**STAFF REPORT: 11-13-2019 MEETING**

**APPLICATION NUMBER: 19-6025**

**ADDRESS: 1474 SHIPHERD**

**SCOPE: WINDOW REPLACEMENT AND REMOVAL, INSTALL REAR STAIRS, REMOVE SYNTHETIC SIDING, EXTERIOR PAINTING, FRONT PORCH REPAIR, SECURITY LIGHTS, ANTENNA**

APPLICANT PHOTOS – NOVEMBER 2018

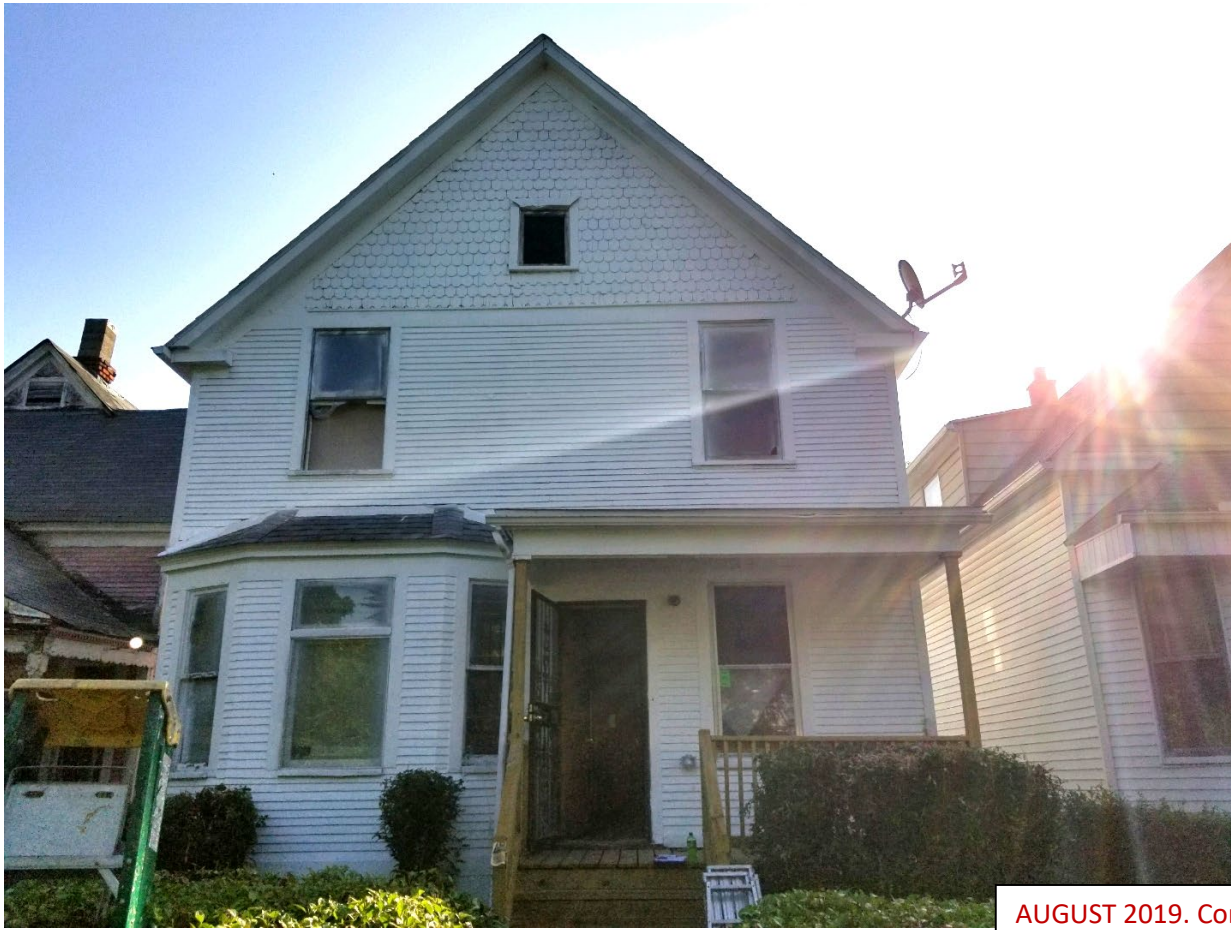
- The new porch mimics the previous porch (which was issued a COA in 2018 for only the repair of the risers and one newel post), but does not match the original porch as shown in the designation slide. The original porch offered detailing to match the vernacular design of the early 20<sup>th</sup> century house and included round porch columns with simple capitals, a square, wide newel post, and straight balusters. The original stair railing was no longer standing (if there had been one to begin with) and two single boards comprised the newel post and handrail. Additionally, a balustrade ran the perimeter of the porch roof, which included identical wide/boxy newel posts. The newly constructed porch and stair retain a contemporary deck appearance due to the railing design, thin, square posts and unfinished surfaces.

- Due to the character-defining elements of the historic porch, the replacement porch should be modified so its appearance closely emulates the original porch, which can be obtained by the following:

- The replacement of the square columns with round columns (of a similar dimension/diameter) which will retain the square trim detail at the top,
- The three existing newel posts will be retained; square newel caps (matching the trim/capital on the porch columns) will be installed so the posts read as individual structural components.

- The exterior porch balusters shall be enclosed at the top rail to match the interior baluster/rail detail.
- The upper porch balustrade shall be rebuilt as depicted in the designation slide.

- All porch items will be painted to eliminate its appearance as a deck. The color will be selected by the applicant and will be submitted to staff for review.
